To:	Steve Senna National Development	From:	Theo Kindermans Stantec Planning and Landscape Architecture
Reference:	<b>BRIDGES AT LEXINGTON</b> <b>56 Watertown Street</b> <b>Log of Site Plan Updates</b>	Date:	May 8, 2019

BRIDGES AT LEXINGTON - SITE PLAN COMPARISON

56 WATERTOWN, LEXINGTON, MA

## EXHIBIT B

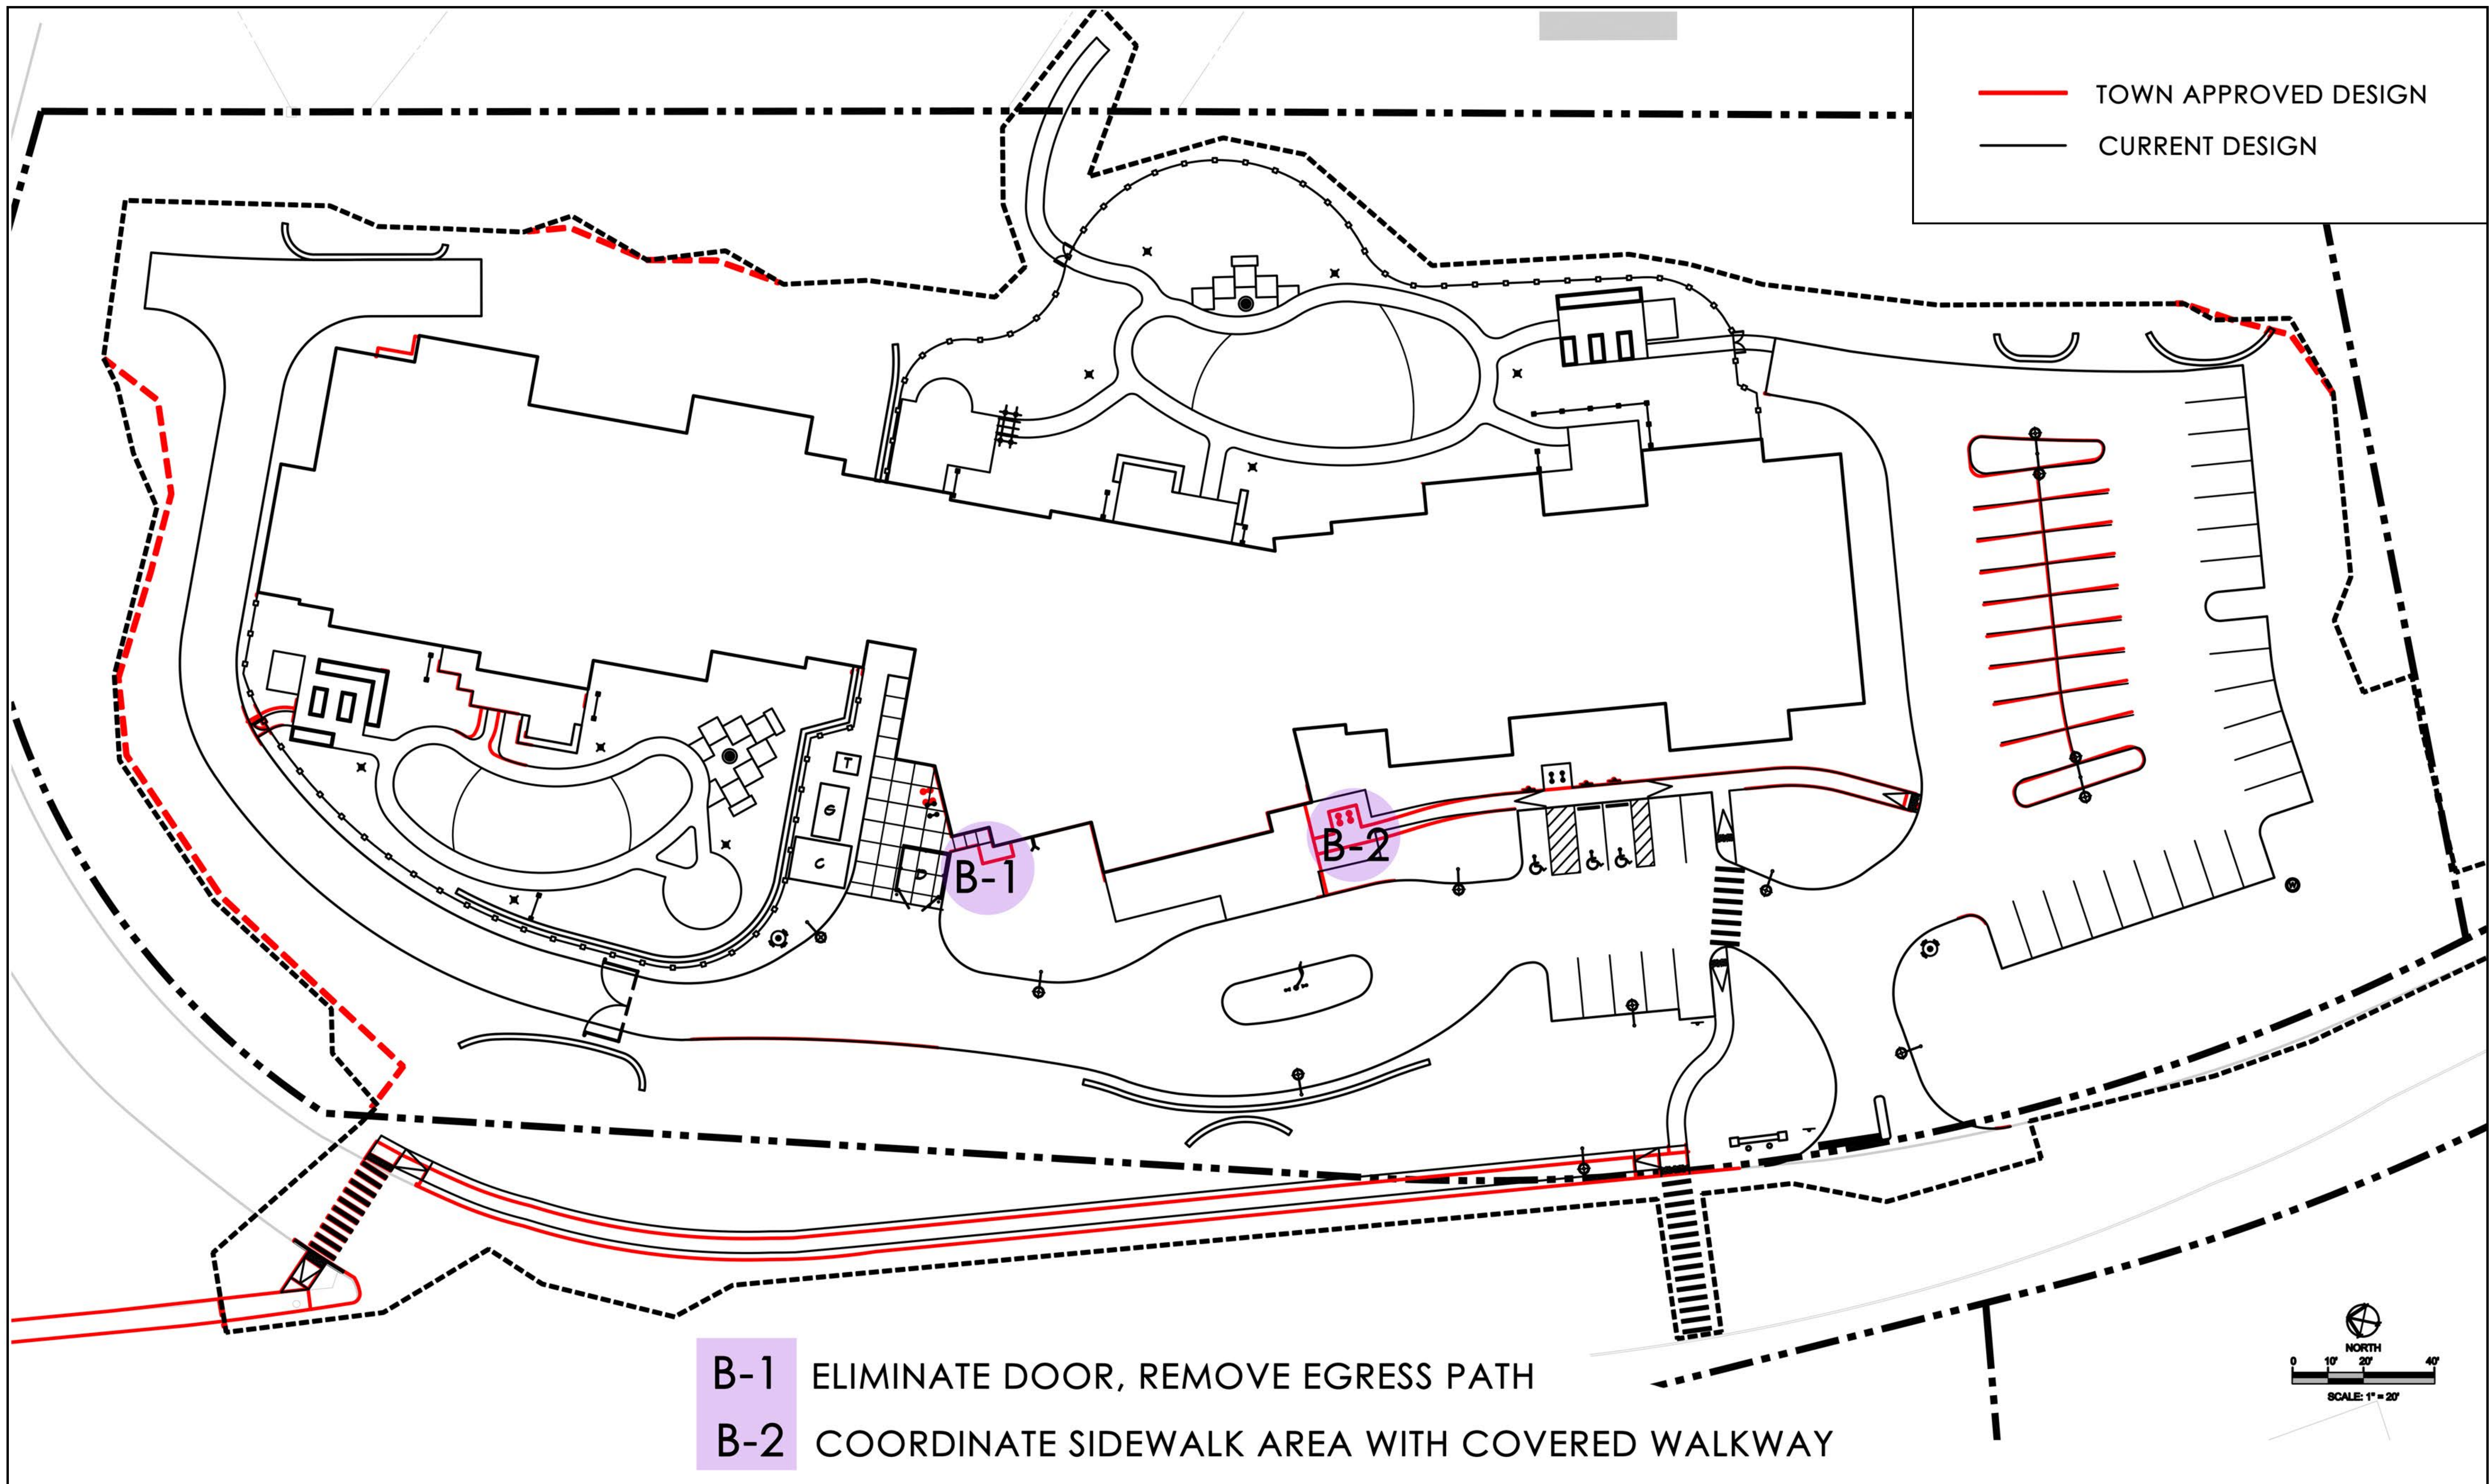
<u>No.</u>	<u>Description</u>	<u>Plan(s) Impacted</u>
1	Added site preparation and erosion control plan, and snow management plan to set.	General/Cover
2	Removed small section of sidewalk to old egress door location. Egress door removed. <i>See Exhibit A, item #A-6 and Exhibit B, item #B-1 for general location.</i>	Layout & Materials Plan
3	Extended sidewalk to better coordinate with extents of entry-covered walkway. <i>See Exhibit A, item #A-7 and Exhibit B, item #B-2 for general location.</i>	Layout & Materials Plan
4	Added crosswalk. <i>See Exhibit A, item #A-3 for general location.</i>	Layout & Materials Plan
5	Disconnected entryway roof leader from area drain; open discharge to bioretention area. <i>See Exhibit A, item #A-6 for general location.</i>	Utility Plan
6	Added roof drain line from building to western subsurface infiltration system.	Utility Plan
7	Renumbered the subsurface infiltration systems for simplicity.	Utility Plan

8	Expanded footprint of bioretention area "BIO2." <i>See Exhibit A, item #A-6 for general location.</i>	Utility Plan
10	Revised drip strip outlet locations.	Utility Plan
11	Modeled drip strips as part of stormwater manage system, which allowed for elimination of NE detention system (formerly system "P3").	Utility Plan
12	Changed subsurface infiltration systems text from "units" to "stacks" ("units" are 0.33' tall and stacked together to form a chamber).	Utility Plan
13	Converted equalization tank to an offline emergency overflow tank. <i>See Exhibit A, item #A-5 for general location.</i>	Utility Plan
14	Moved irrigation well to south end of site for better drill rig access.	Utility Plan
15	Added evergreens to supplement buffer to abutters. <i>See Exhibit A, item #A-4 for general location.</i>	Planting Plan
16	Shifted trees further off curb to accommodate snow storage. <i>See Exhibit A, item #A-2 for general location.</i>	Planting Plan

17	Added street light on Watertown Street per MOA commitments. Added note regarding uplights at entry signage. <i>See Exhibit A, item #A-1 for general location.</i>	Lighting Plan
